Distribution System Operation (DSO) Infrastructure

ED2 Engineering Justification Paper Addendum

ED2-NLR(O)-SPEN-001-DSO-EJP-ADD

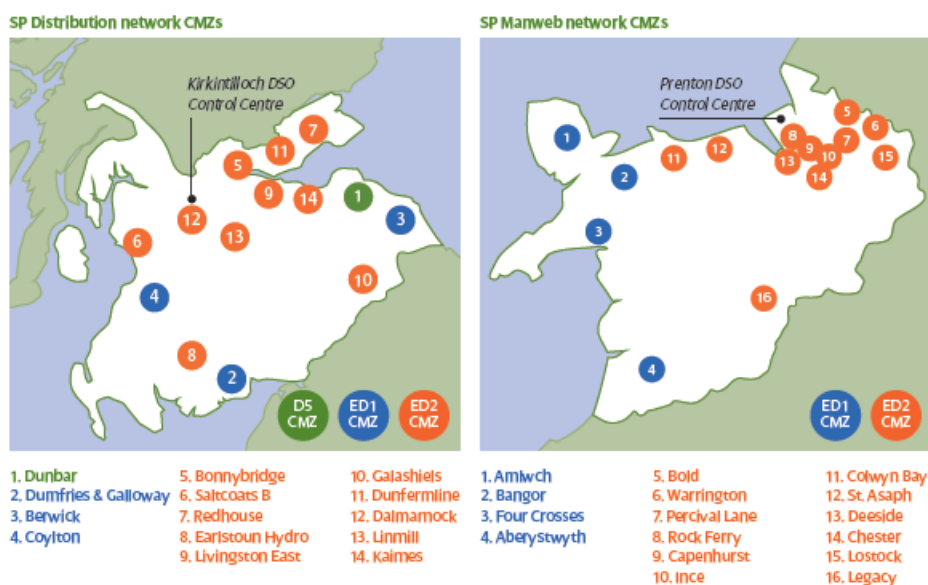
Ofgem Comment - Partially Justified - We agree with the needs case and optioneering presented by SPEN, however there is uncertainty in relation to the proposed volumes

Ofgem Identified Risks - There is uncertainty in the volume, location and size of CMZs, therefore there is a risk that such changes will impact the proposed project costs.

Our CMZs will be rolled out in a priority order based on these assessments and are shown in the figure below. We will keep the priority order of the roll out of CMZs under review, and if additional constrained areas arise within RIIO-ED2, we will seek to ensure the CMZ infrastructure includes the additional areas. The centralised CMZ infrastructure has been designed to be scalable and can be extended as required.

The phasing, and location of the CMZs can be adjusted to meet emerging requirements and stakeholder needs. For example, if a location receives its forecast generation or demand earlier based on an updated DFES forecast, it would be considered for acceleration of the deployment of that CMZ. The architectural design and the focus on meeting customer requirements, means that this conservative deployment in the face of new external factors, reduces the risk of stranded assets while prioritising customer and network need – as highlighted in Section 5.7 on deployment scale risk.
